CPP Project 9020

Attn: Mr Marc Yeo
Project: Cockle Bay

Please find herein an assessment regarding the applicability of the wind tunnel test results for the Cockle Bay Park Development for the currently proposed envelope.

Figure 1: Wind tunnel model of the previous design (T), and currently proposed envelope (B) of the Cockle Bay Park Development viewed from the north-west.

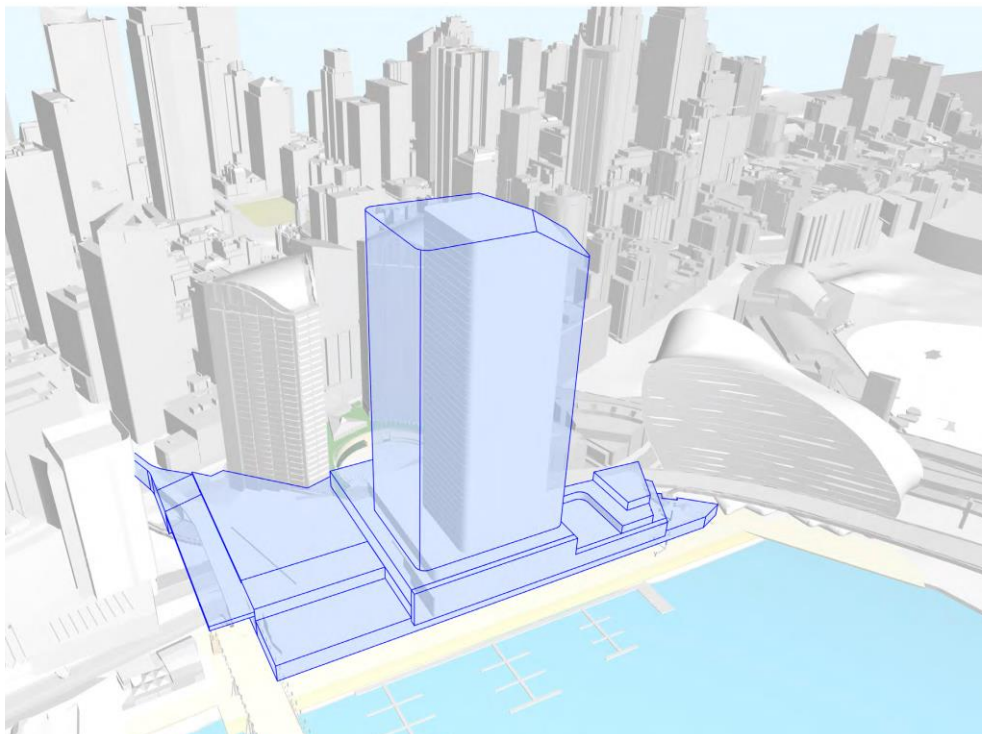
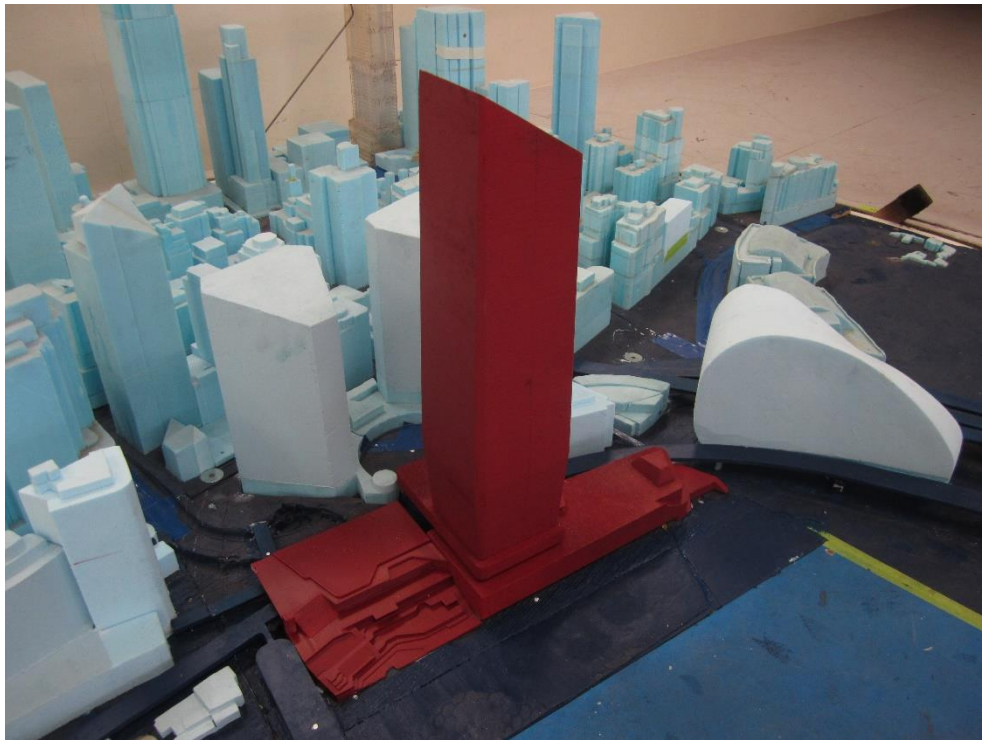
Comparative images of the tested design and the currently proposed envelope are presented in Figure 1. The main changes between the amended EIS (2017) envelope and the currently proposed envelope are a shift of the building location within the concept envelope to the south, a reduction in the height of the tower, and an increase in the tower width. The northern façade is moved south by 8 m while the southern façade is moved by 15 m, and the height is reduced by 12 m. The currently proposed envelope also foresees minor changes to the podium.

The change in the building massing would slightly change the wind conditions locally in some areas of the precinct. The total amount of downwash generated by the facades of the tower would be expected to remain similar to the tested design as reported in Cermak Peterka Petersen (2017). The wider west façade of the tower would be expected to cause a slight increase in downwash flows affecting ground level, while the reduction of the tower height would likely reduce downwash relative to the previous design. Note that although the envelope has increased in width, any building within the envelope would be limited to 60 m in width, which is consistent with that assessed in the 2017 assessment.

Overall, the wind conditions at ground level would be expected to remain similar to the conditions measured in the previous wind tunnel test. The changes to the building massing would be expected to mainly affect areas on the podium, which are subject to further design for the Stage 2 SSDA and as such will be refined during the design excellence process
